UNITED STATES PATENT AND TRADEMARK OFFICE

Office Action Summary

09/902,310

ALBRECHT ET AL.

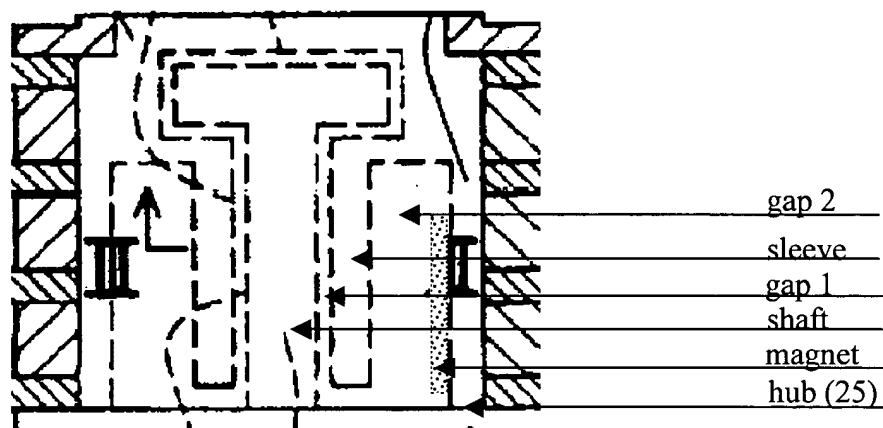
14. Applicants argument that there is only one gap disclosed in patent '366, the Examiner disagrees. In figure 2, Ichiyama shows a first gap between the shaft and the sleeve and a second gap between the sleeve and the hub. Applicants argument that the microgap exists between the shaft and the magnet, the Examiner disagrees. The magnets are located inside member 25, as Applicants acknowledge, but this does not mean that the gap is between the magnets and the shaft, but rather inside the member 25. As shown below, there is a gap between the sleeve and the hub.
